Public Comments Agenda Item 5

Subject: City Council agenda item 5 tonight, single family home at Talbot Avenue terminus

RE: Talbot Avenue project, APN 016-270-190

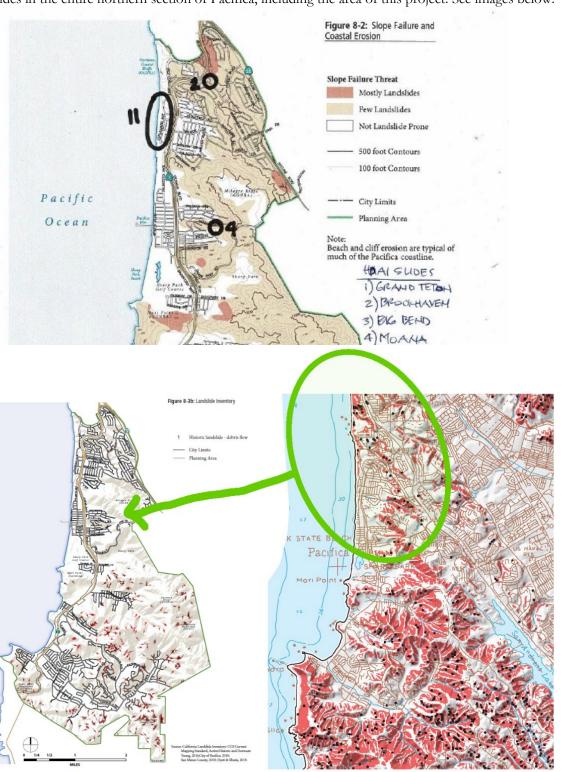
I took a Google Earth image along Talbot that shows both the proposed property and the location of the Moana slide. See below. Except for the proposed driveway and upper section of the home, the slopes are identical at 1:1 or 100% slope.

> CROSS SECTION A-A'
> MOANA SLOPE FAILURE
> HOWARD • DONLEY ASSOCIATES, INC. CONSULTING ENGINEERS & GEOLOGISTS

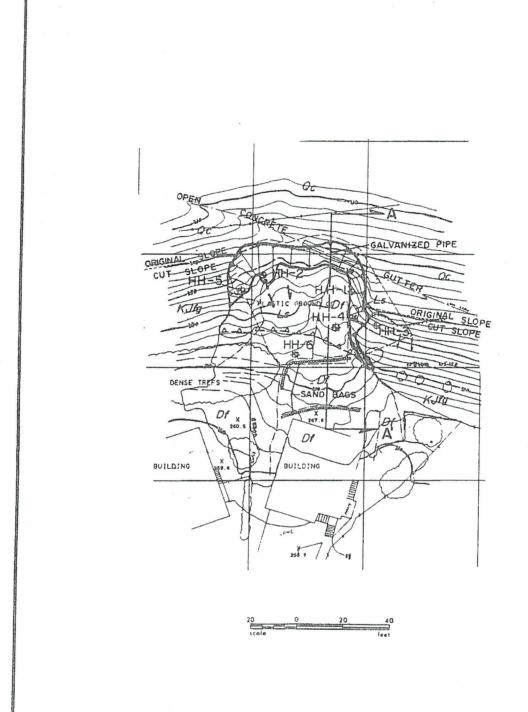
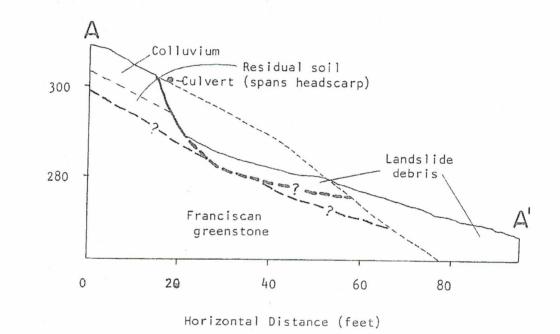
the failure occurred across the cut slope approximately twelve feet above the foot of the slope as seen on Plate 11, Cross Section A-A'.
